**September 16, 2021**

**SOLICITATION ADDENDUM NO. 2**  
**ITB 21-0006**  
**Mountainside High School Field Turf Remediation**

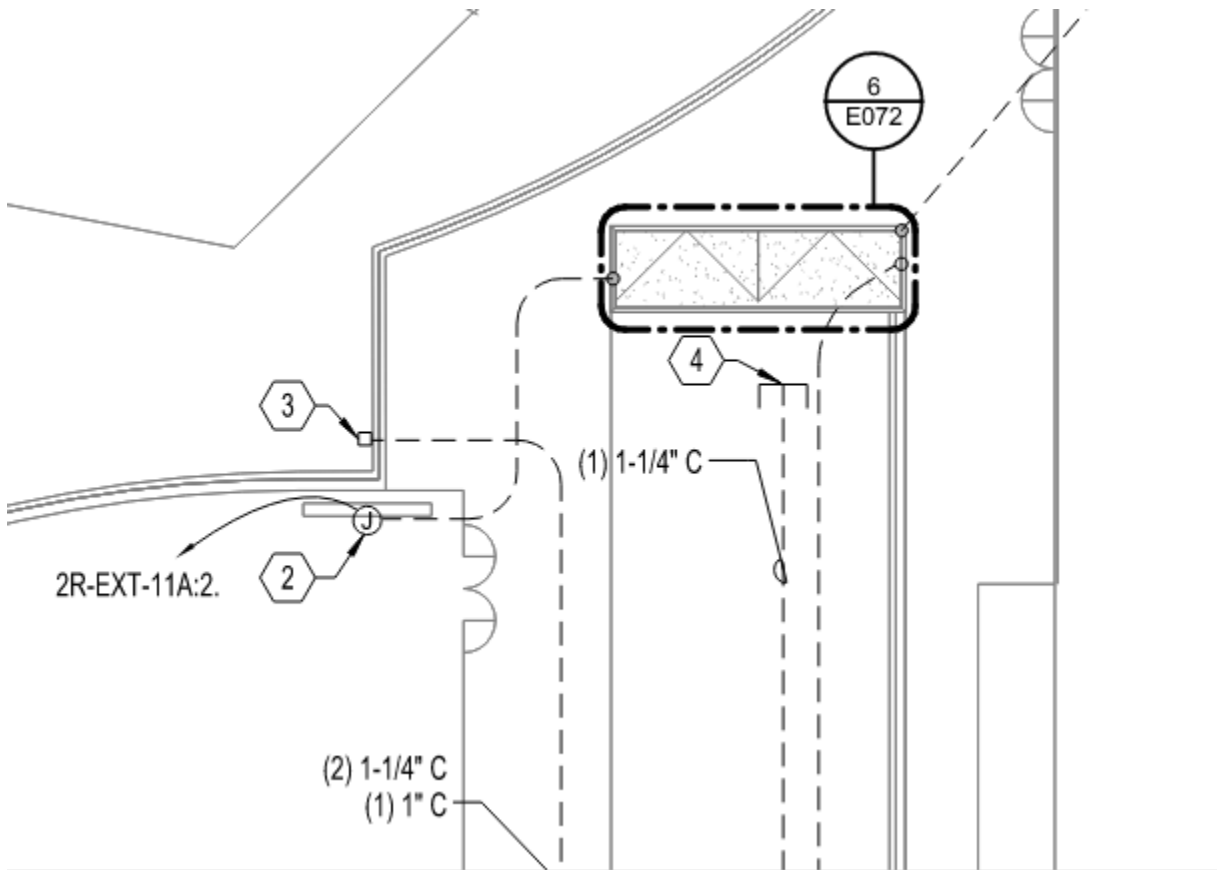
QUESTION: What is the concrete thickness in the area between the fields? For equipment?

ANSWER: **The concrete is vehicle rated - 6" thick with #4 rebar @ 24" oc.**

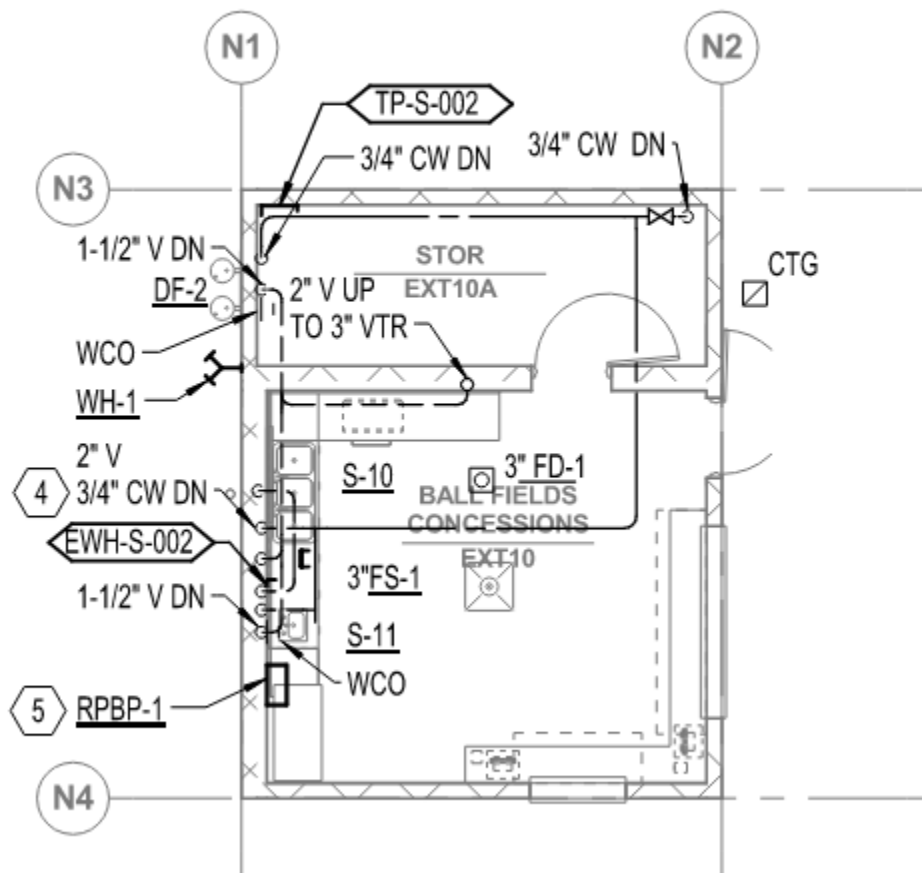
QUESTION: Where is the nearest water source? Access?

ANSWER: **The nearest water spigot is on the concessions building at the southeast side of the varsity field.**
